Reference: **Alex Avenue Public School
Farmland Drive, Schofields NSW 2762**

ACCESS REPORT – SSD

ALEX AVENUE PUBLIC SCHOOL FARMLAND DRIVE SCHOFIELDS NSW 2762

Revision **[D]**

Ground floor plan

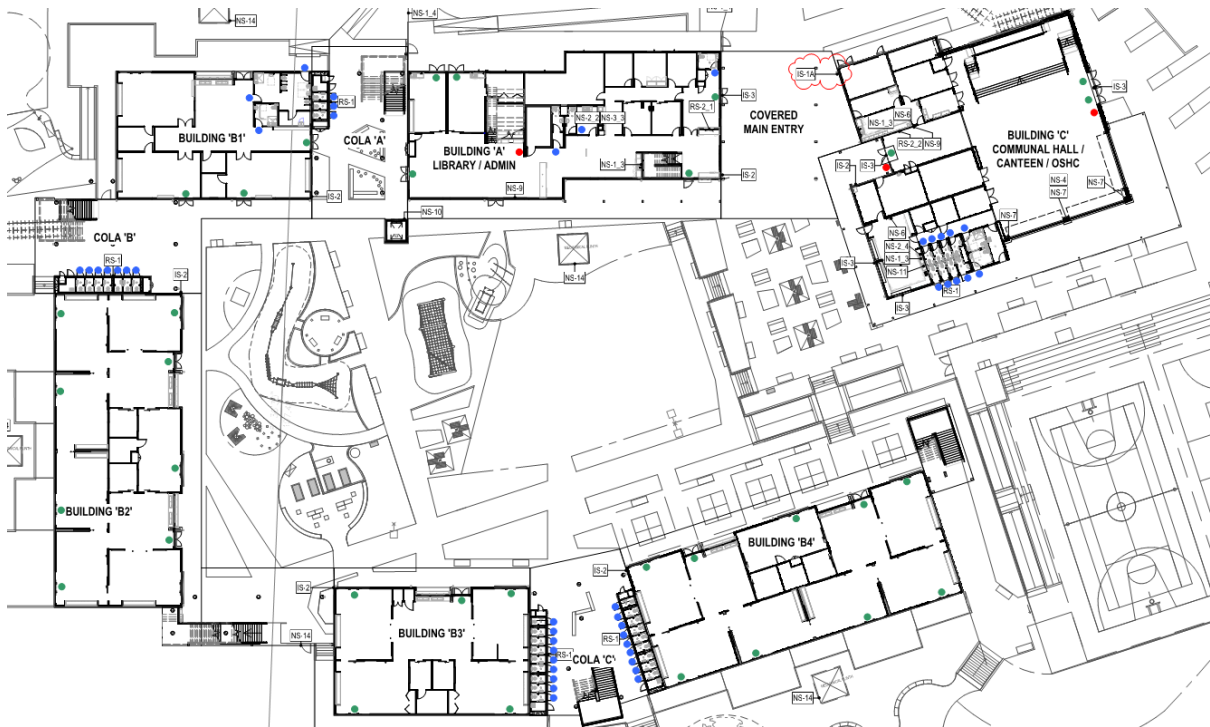
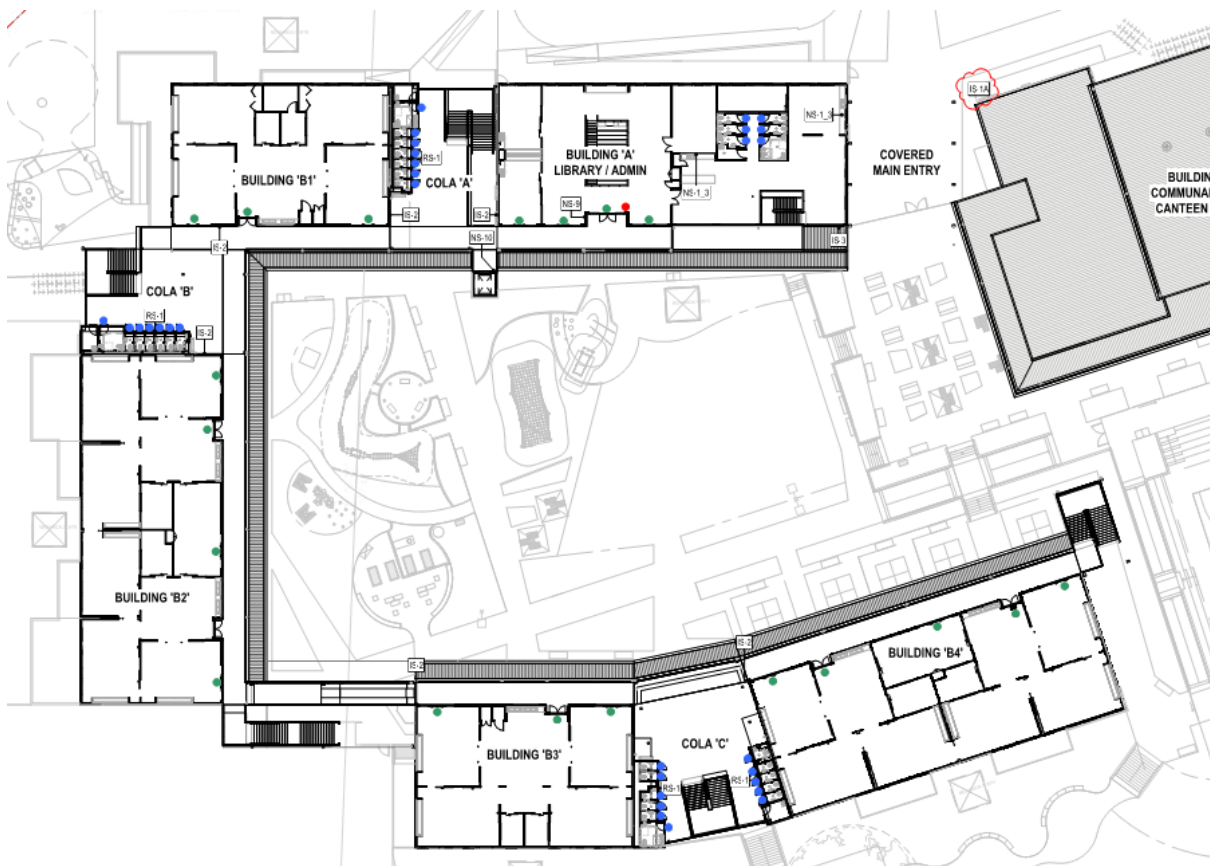
These documents do not locate the locations of the statutory signage associated with WC, Exits or locations where hearing augmentation is provided.

The plans have been marked up indicating the locations of statutory signage.

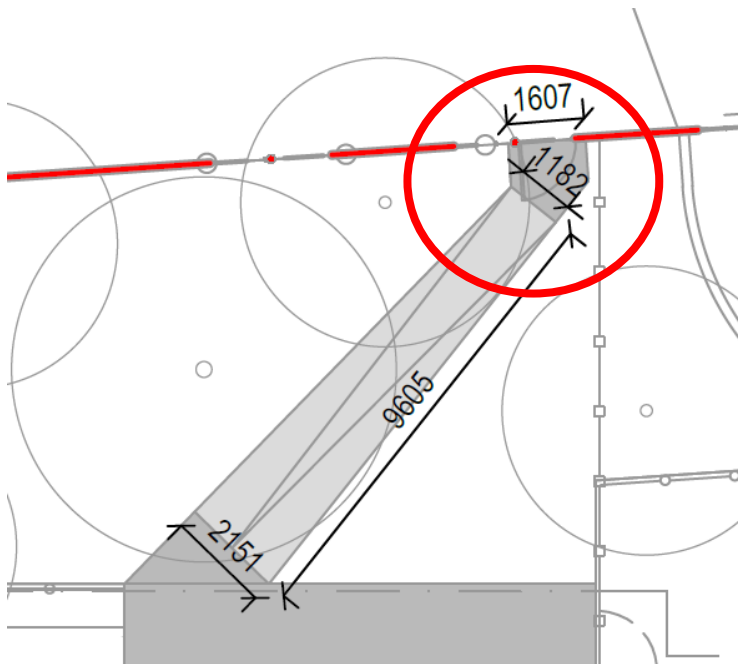
The detailing of the entry gate will need to be revised to provide a minimum 530mm latchside clearance and a 1450mm deep landing zone associated with the gate. Perhaps the handing of the gate could be reversed so that the swing of the gate does not clash with the handrail details of the 1:20 ramp.

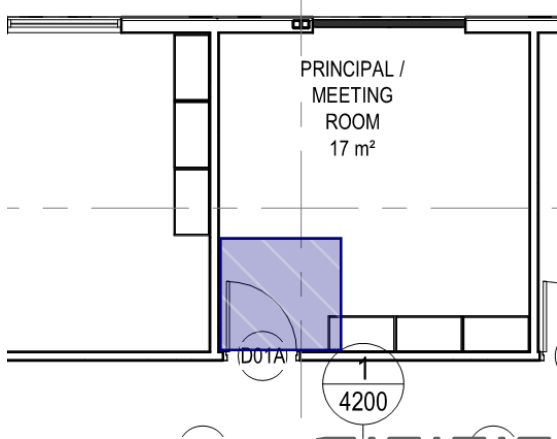
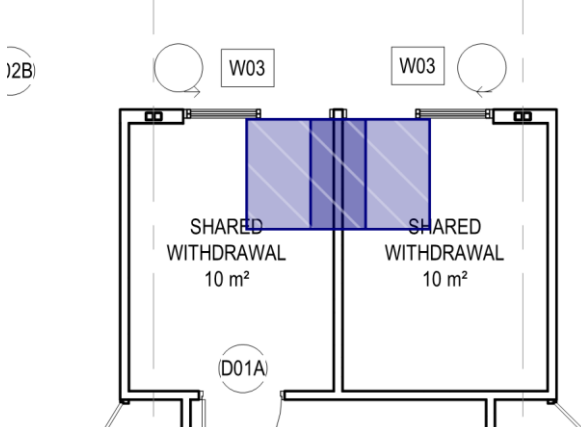
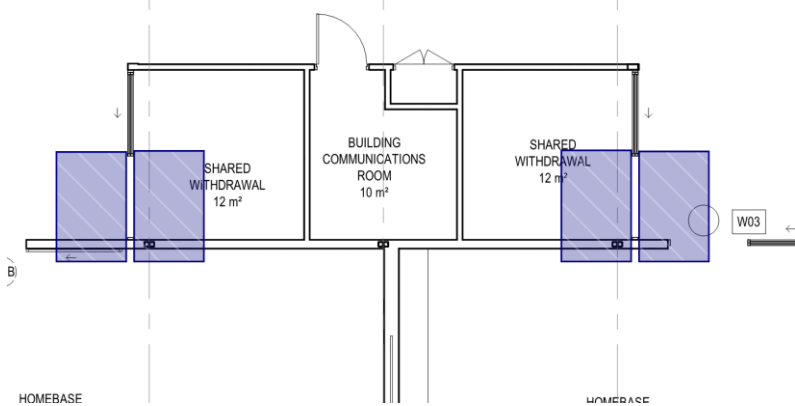
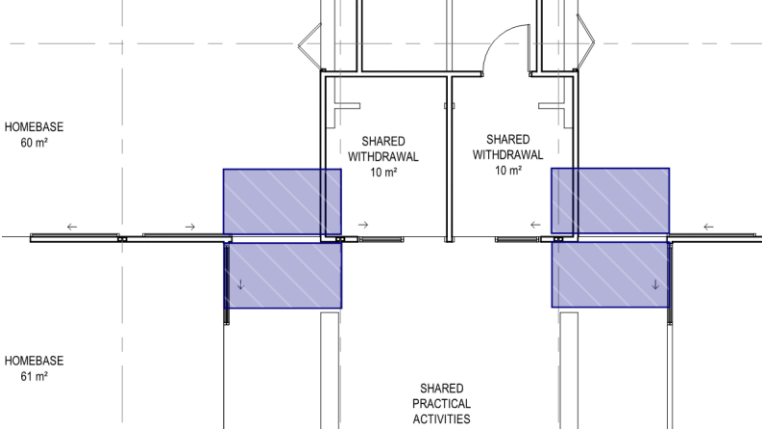
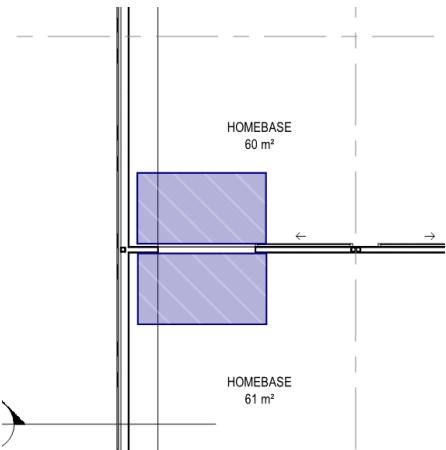
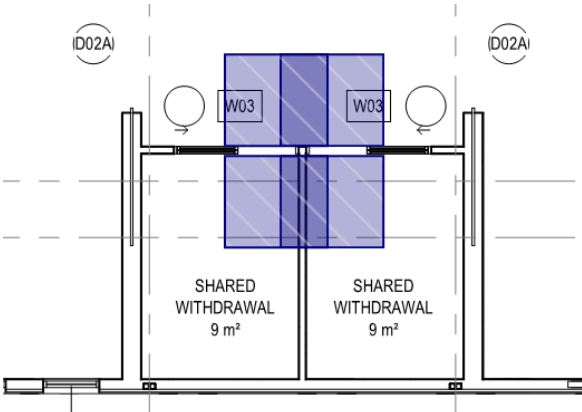
A Performance Solution is to be prepared to address the circulation at doorway requirements of the sliding doors between GLAs

Figure 34 – Extract from Ground Level Block C

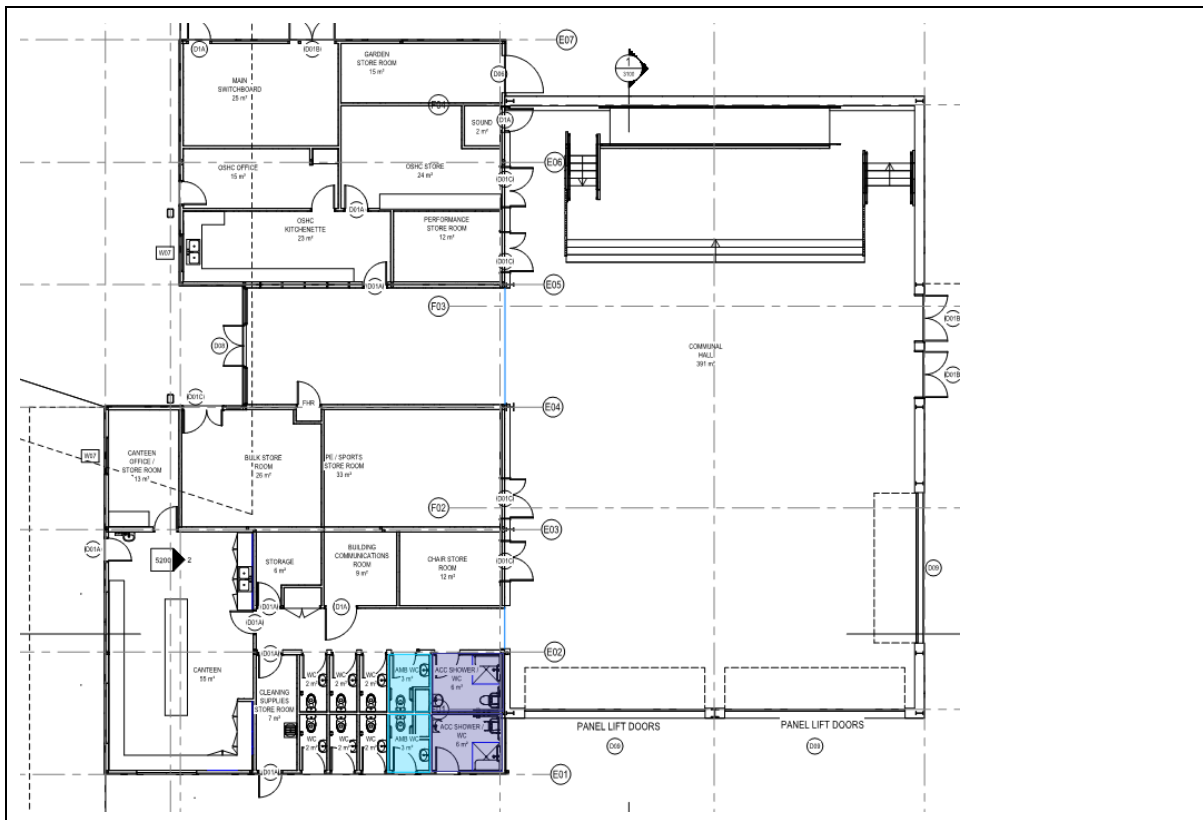
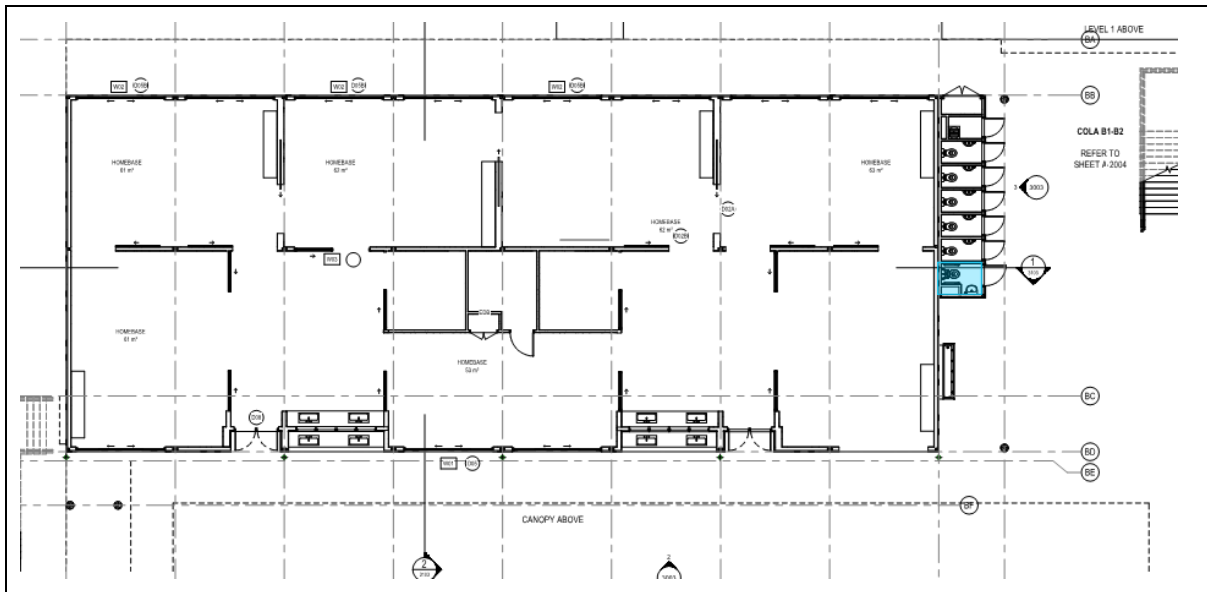
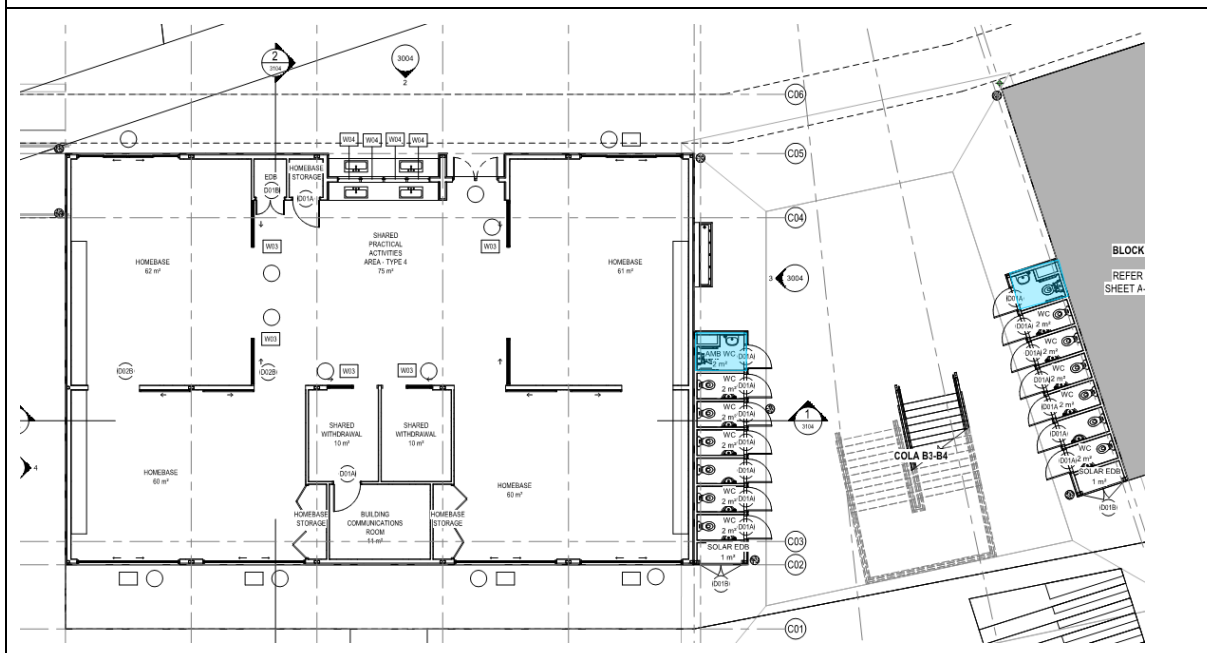
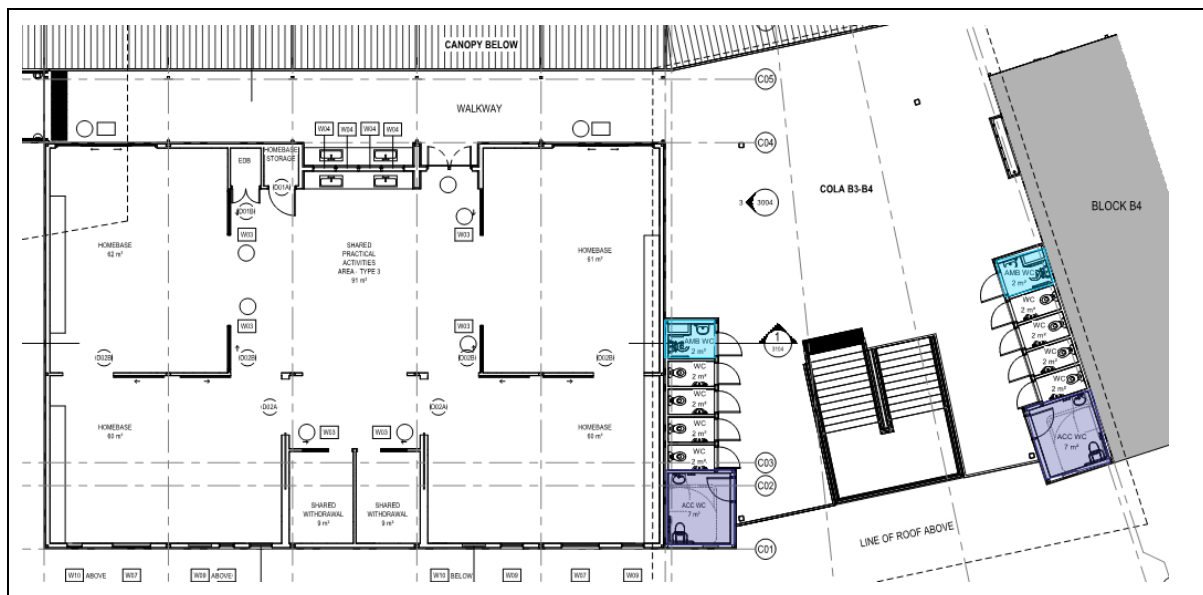
<p>Compliance: The drawing set will need to include detailed documentation of all ambulant and accessible sanitary facilities to indicate compliance with the provisions of AS1428.1:2009.</p>
